Report Type: DA Access Report
Reference Number: 18148
Client: Prestige Development Group c/o Morson Group
Site Address: 16-24 Hope Street, Penrith

ACCESS REPORT

This Access Compliance Report is to accompany a Development Application for the development proposed at 16-24 Hope Street, Penrith

Basement 1 shown above

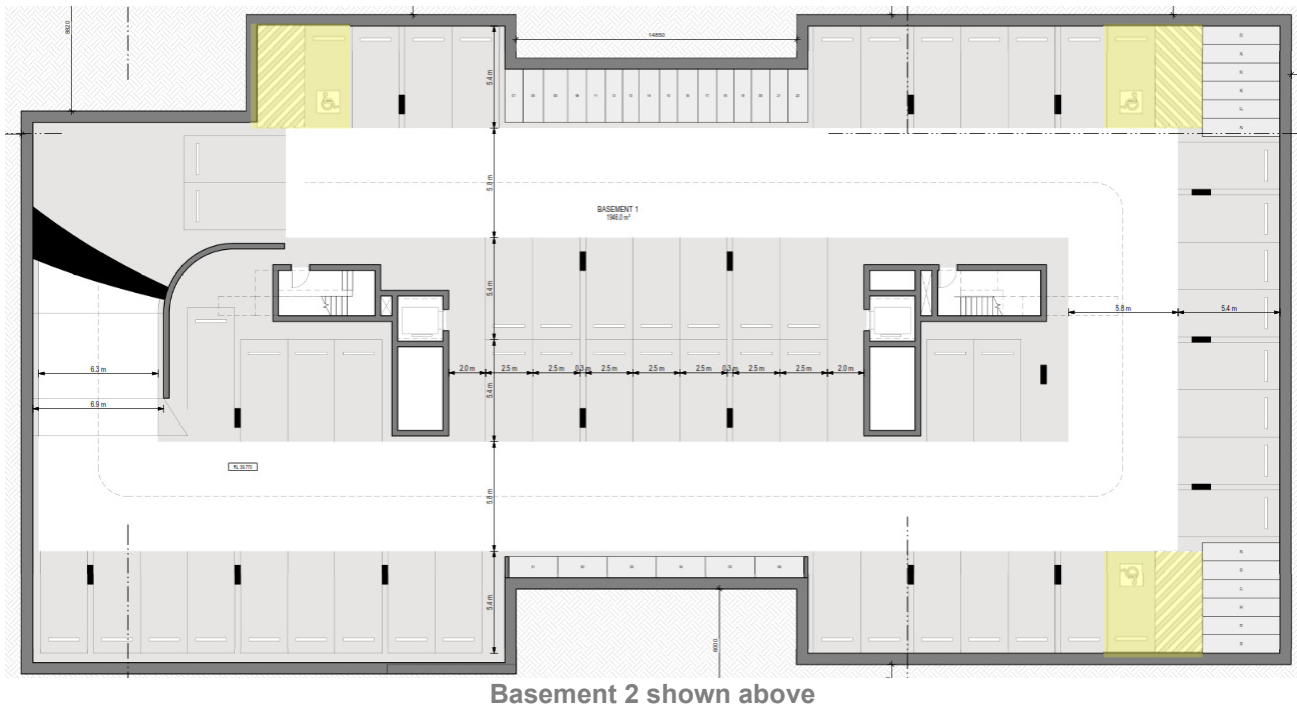
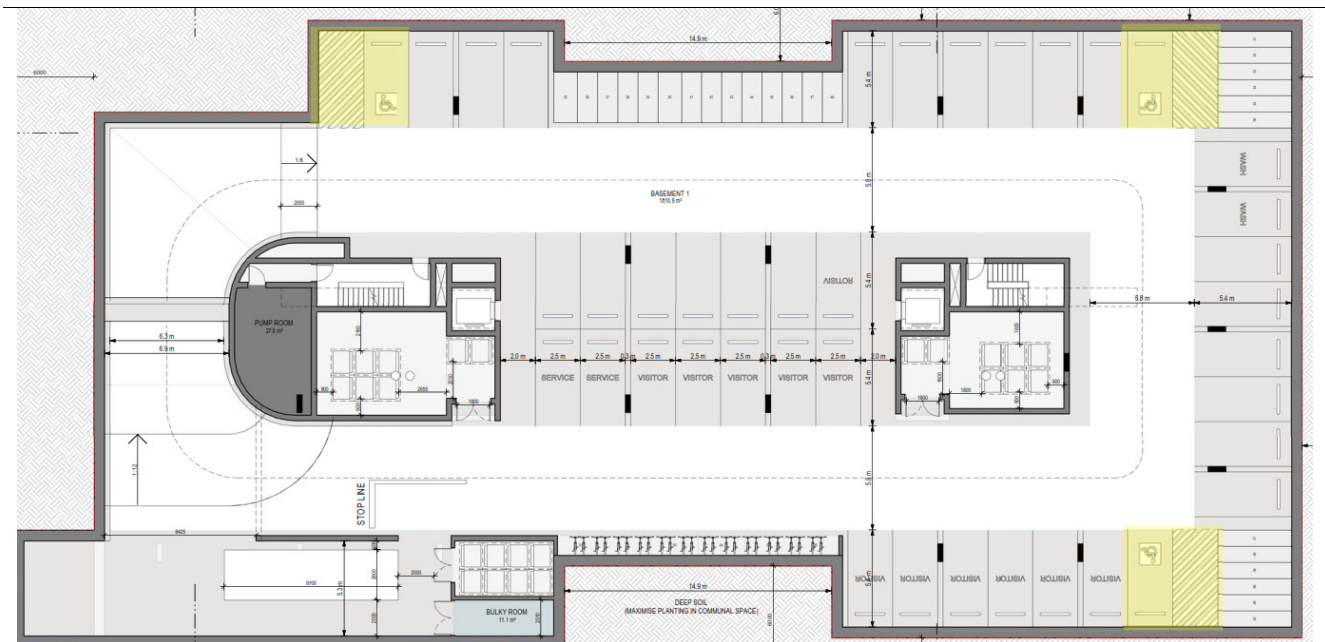
The Accessible parking, shared zones, linemarking and bollards to be as shown above.
Access symbol is not to be provided when spaces are allocated to Adaptable units.
